5 items to resolve before final renders

R-01 · Drawing review

RECEIVED	RETURNED WITH	BY
GF plan + elevations, Rev A	A-101 Rev B + updated 3D model	Zyplab studio

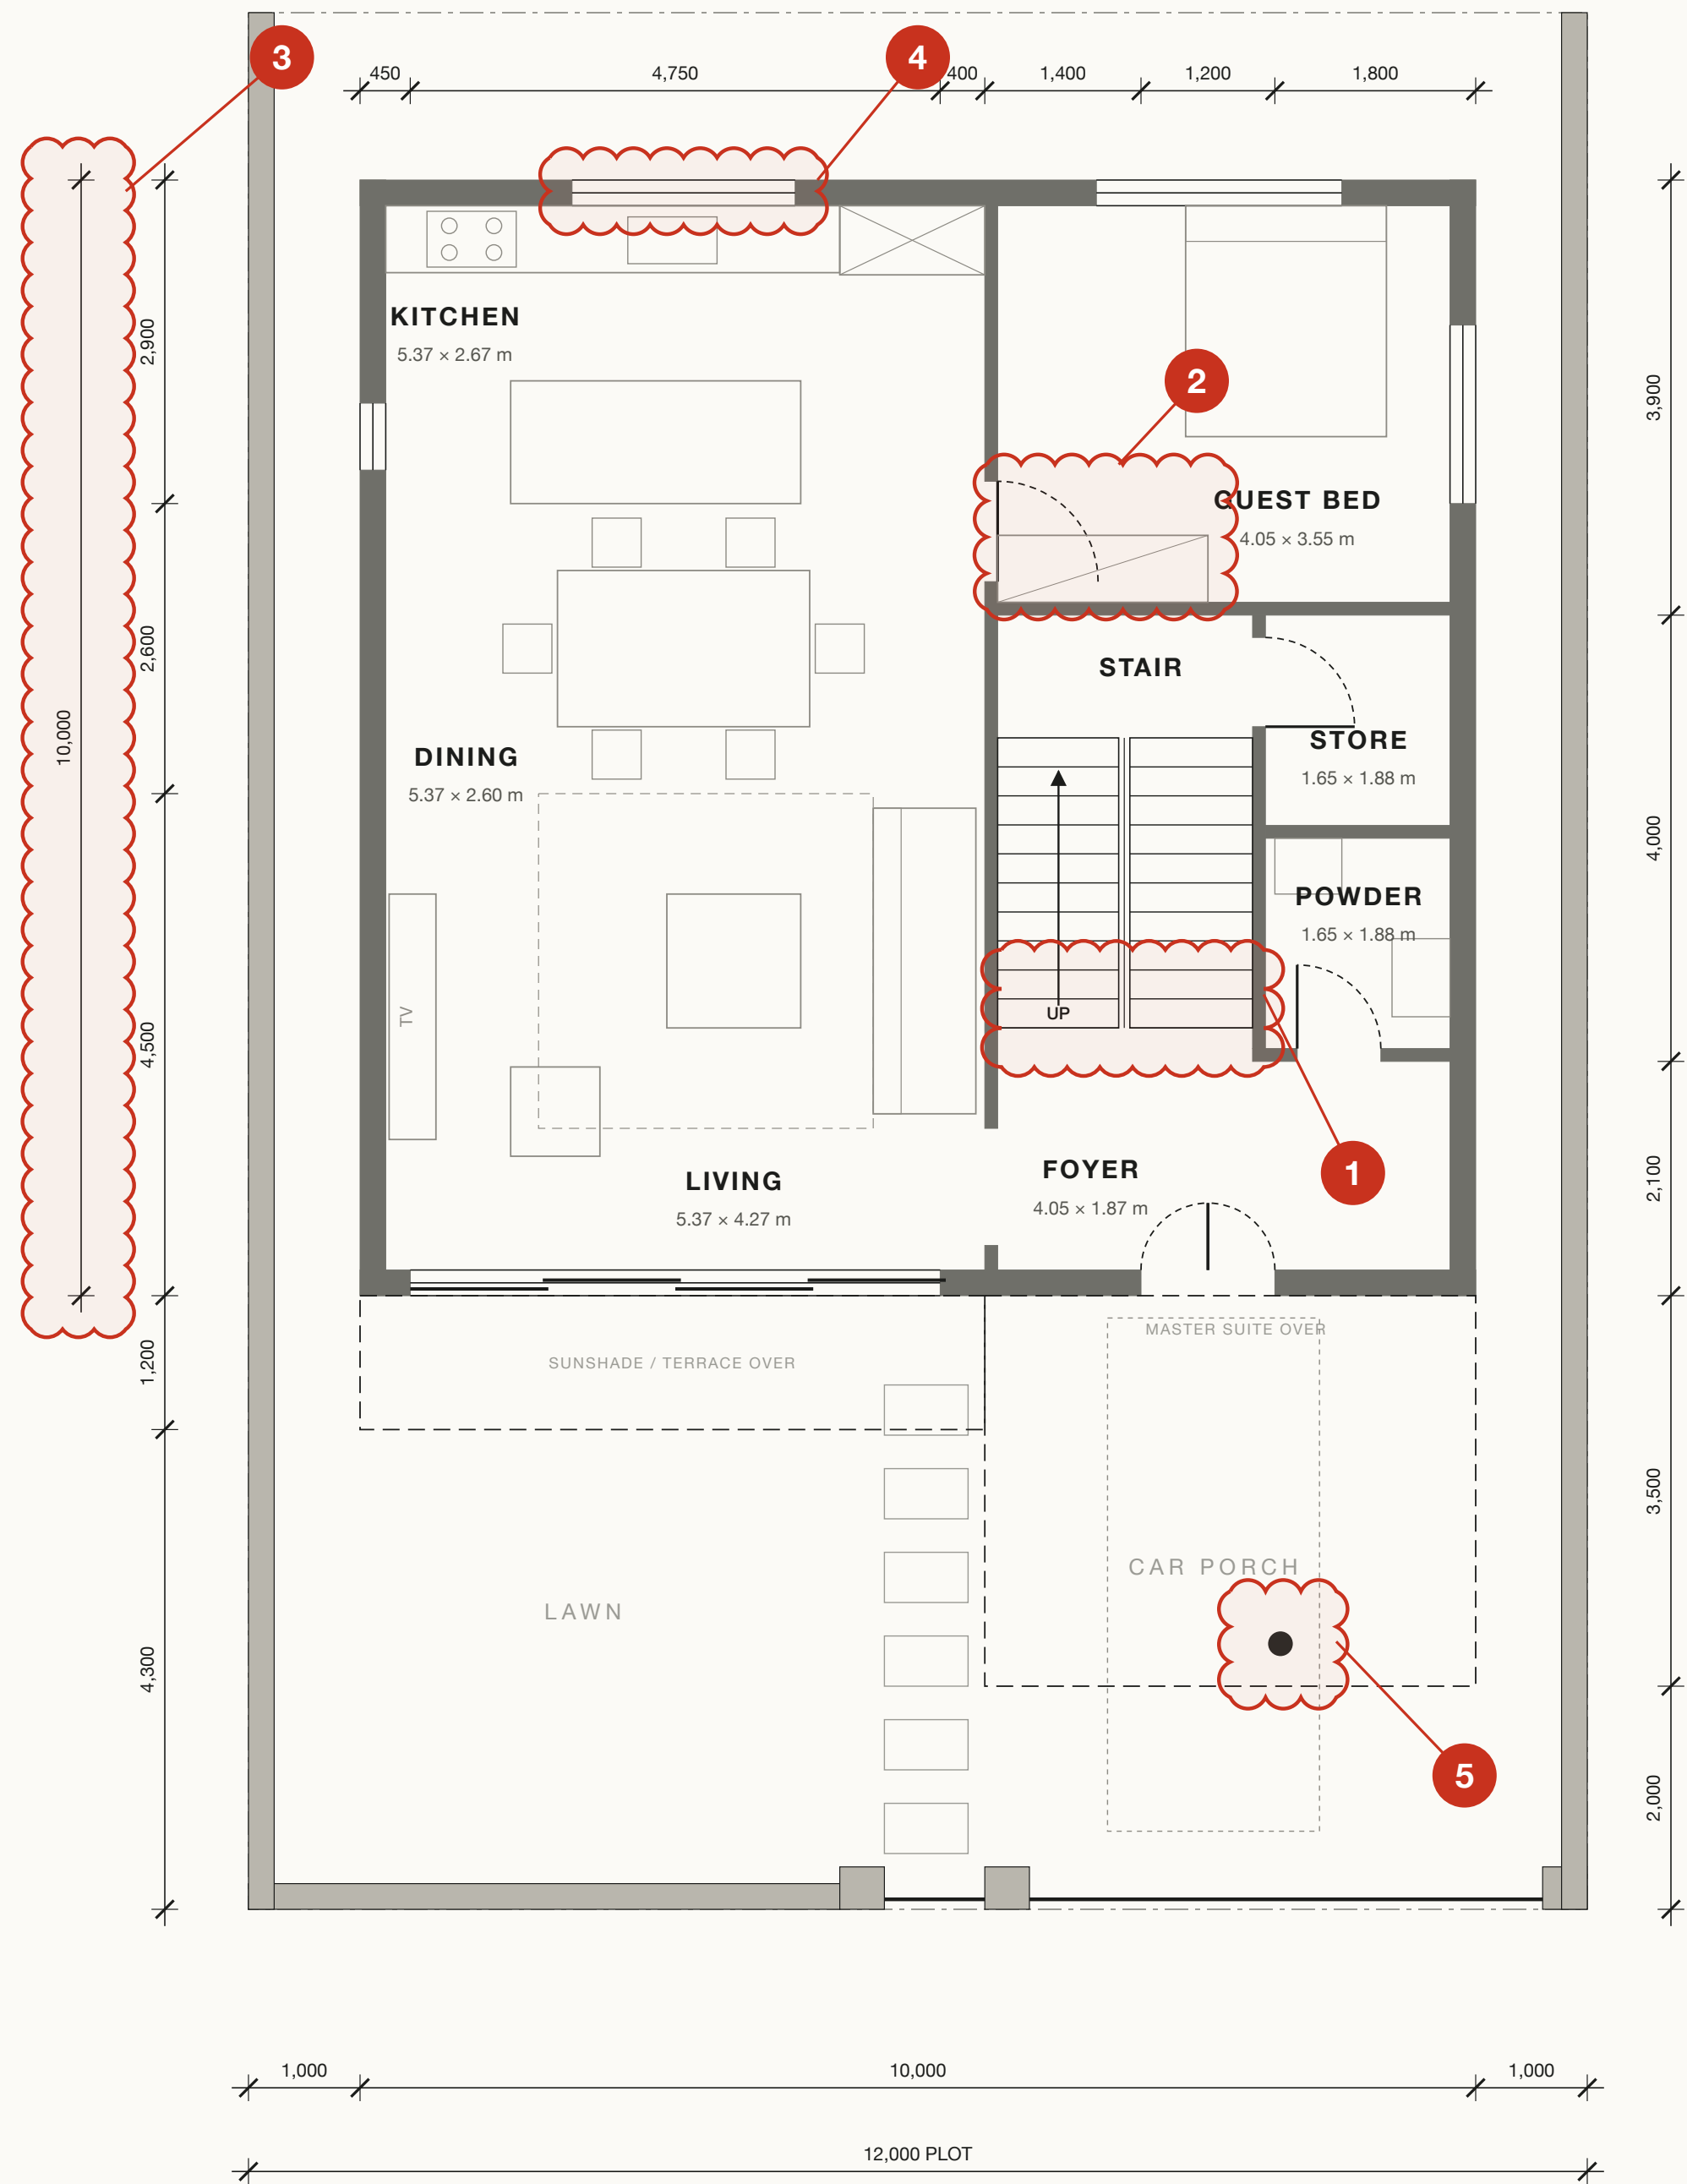
Flight 1 starts under the first-floor landing beam. Clear headroom at riser 3 = 1.98 m, below the 2.2 m minimum (NBC 2016).

Guest-room door (900) swings into the 600-deep wardrobe on the stair-side wall. Shutters and door cannot open together.

Overall depth reads 10,000 on this plan but 10,150 on the side elevation. 150 mm unaccounted for.

Elevation shows the kitchen window sill at +900. Counter is +900 and the backsplash needs at least 150 above it.

Column at grid C sits 2.65 m from the house wall. A parked car cannot open its doors on both sides.

Fix: Make the landing beam a flat beam within the slab, or start flight 1 two treads further in. Headroom becomes 2.25 m.

Fix: Move the door 1.1 m along the dining wall (y 13.0–13.9). Wardrobe and bed layout unchanged.

Fix: Confirm the correct figure before we lock the model. We have modelled 10,000 (plan governs) until you confirm.

Fix: Raise the sill to +1,050 (head stays at +2,300). Shown in the kitchen render.

Fix: Move the column to the front corner (as A-101) and carry the master-suite slab as a 3.1 m cantilever beam. Needs your structural engineer to confirm.
